**ADDENDUM # 4**

**RFB #: RFB-RC-SWR-2023-06**  
**Screening Improvements Project**

**ADDENDUM 04**

Screening Improvements Project  
Contract No. RFB-RC-SWR-2023-06  
SRF Project No. C3-5368-35-00  
Rockland County Sewer District No. 1

DATE:	JUNE 2024
HAZEN NO.:	90462-000
CONT NO.:	RFB-RC-SWR-2023-06
DRAWING NUMBER:	C-02

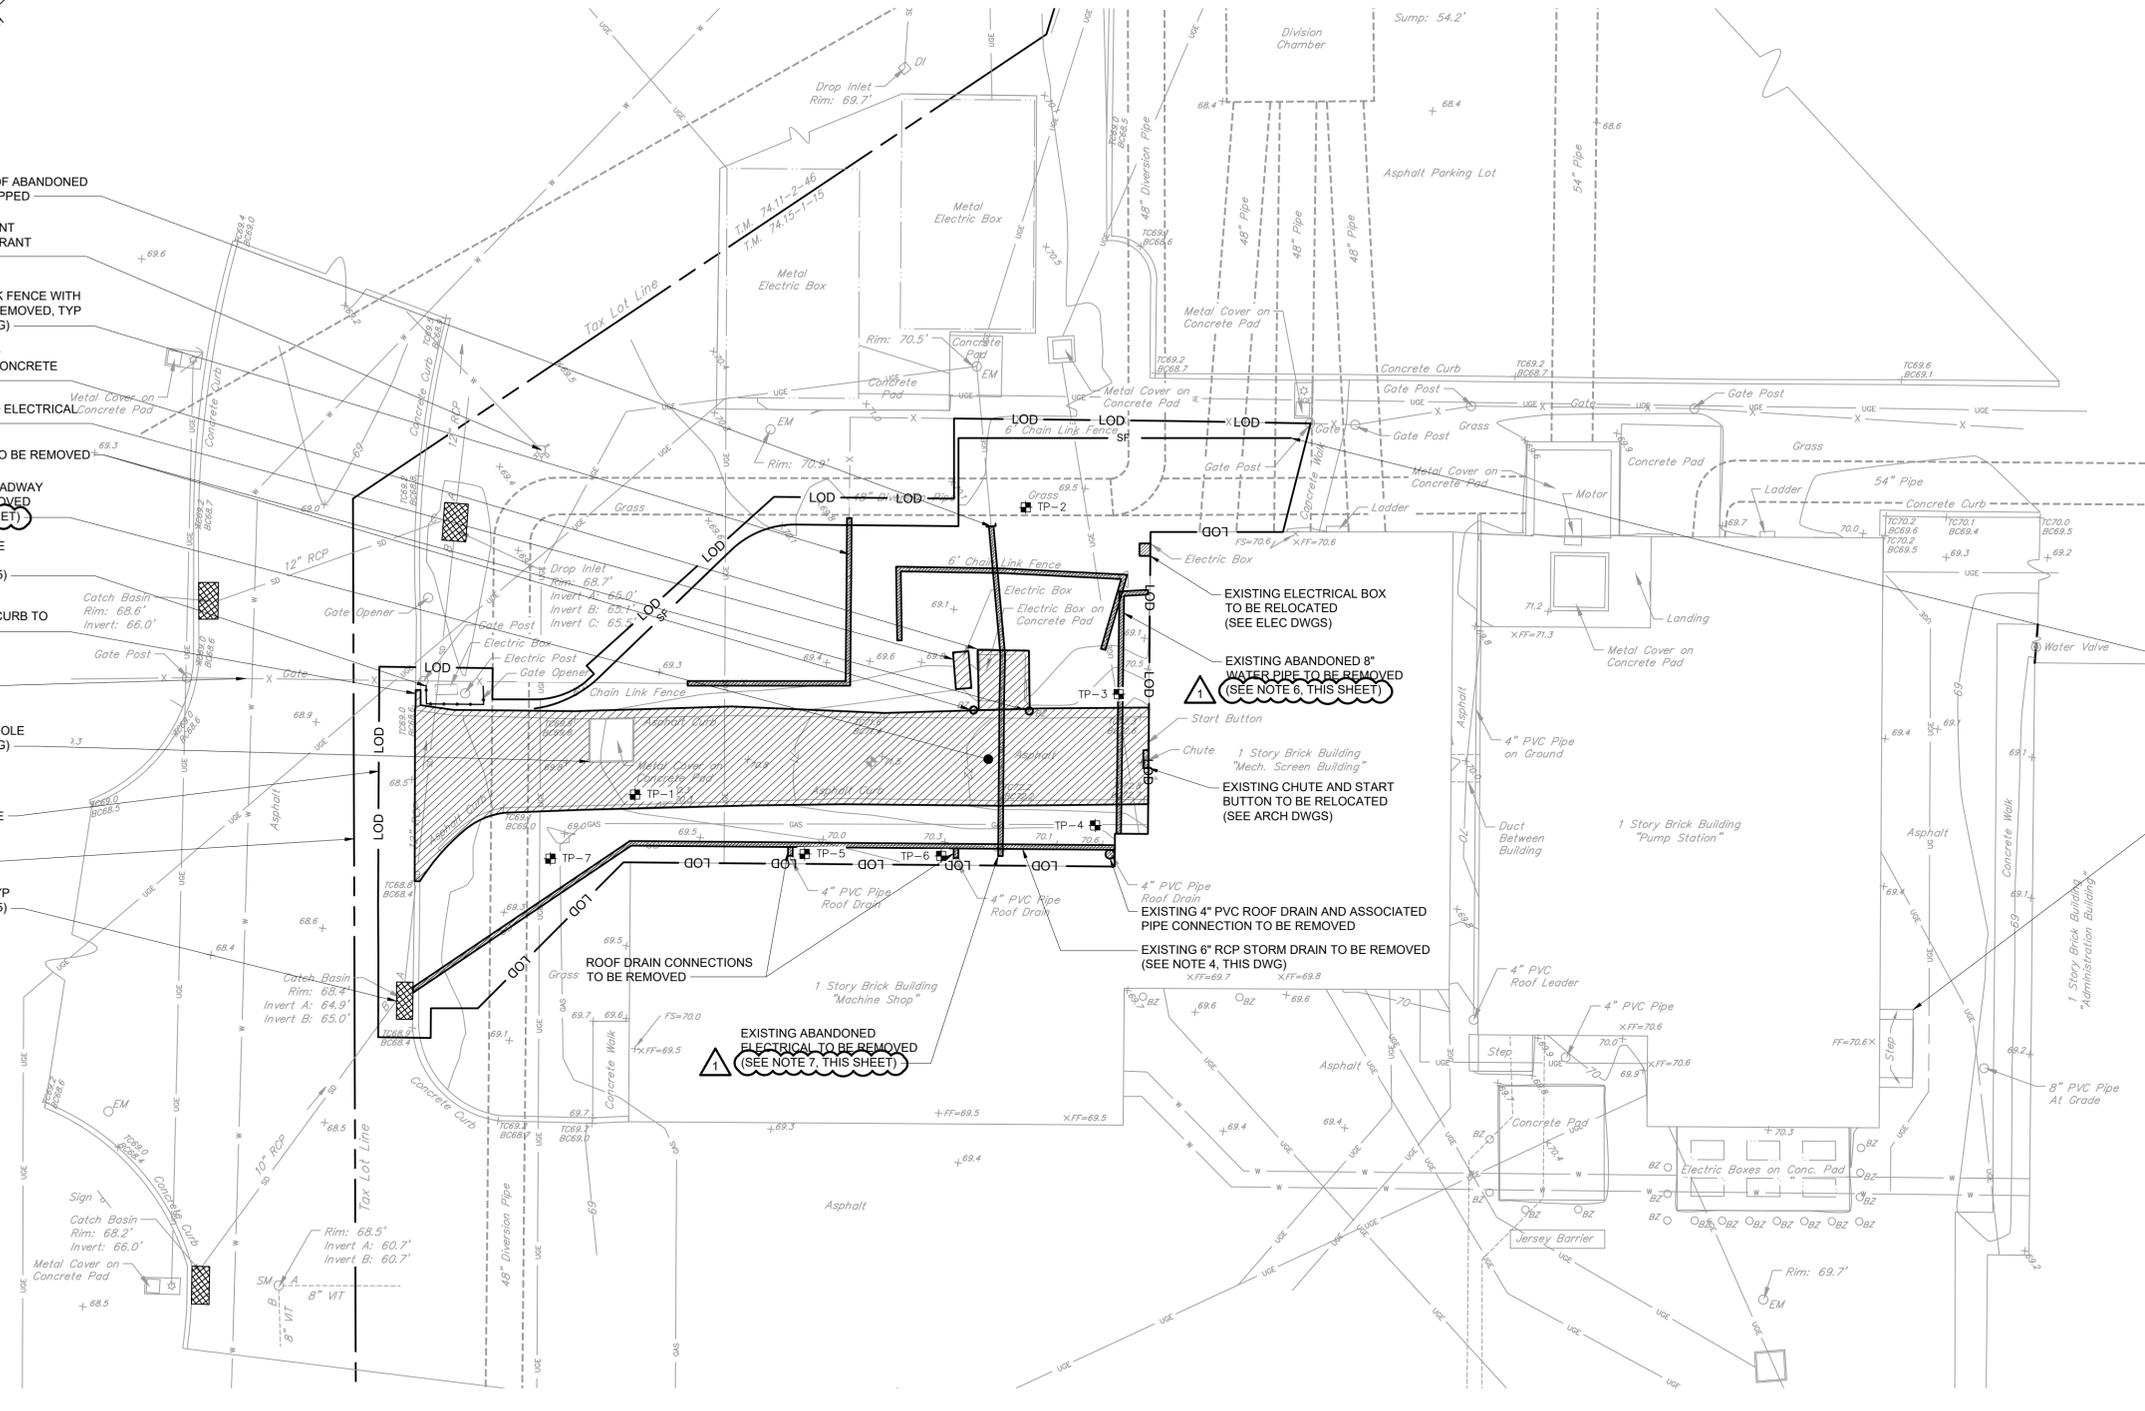
Page C-02 shows 30 LF of 8" Water pipe to be removed, and approximately 40 LF of abandoned electrical to be removed. Please provide the size, material and depth of the electrical line to be removed and the material and depth of existing water line to be removed.

Page C-02 shows 885 SF of asphalt to be removed. Please provide the thickness for the asphalt to be removed.

On page C-02, there is approximately 85 LF of RCP storm drain to be removed. Please provide the approximate depth of this pipe.

**Response:** There are no available record documents that provide the depth or material of the water or electric. Drawing C-02 has been revised through this Addendum to indicate an assumed depth, material, and size.

**Response:** Drawing C-02 has been revised through this Addendum to note the assumed pavement thickness, based on the geotechnical boring done in the driveway.

**Response:** Drawing C-02 has been revised through this Addendum; refer to note 4 on revised Drawing C-02.

7. NO AVAILABLE RECORDS FOR ELECTRICAL'S SIZE, MATERIAL, OR DEPTH. CONTRACTOR SHALL ASSUME 2" x 2" CONCRETE DUCT BANK WITH A TOP OF DUCT BANK ELEVATION OF 66.5.

8. CONTRACTOR SHALL ASSUME THE DEPTH OF ASPHALT TO BE THREE INCHES.
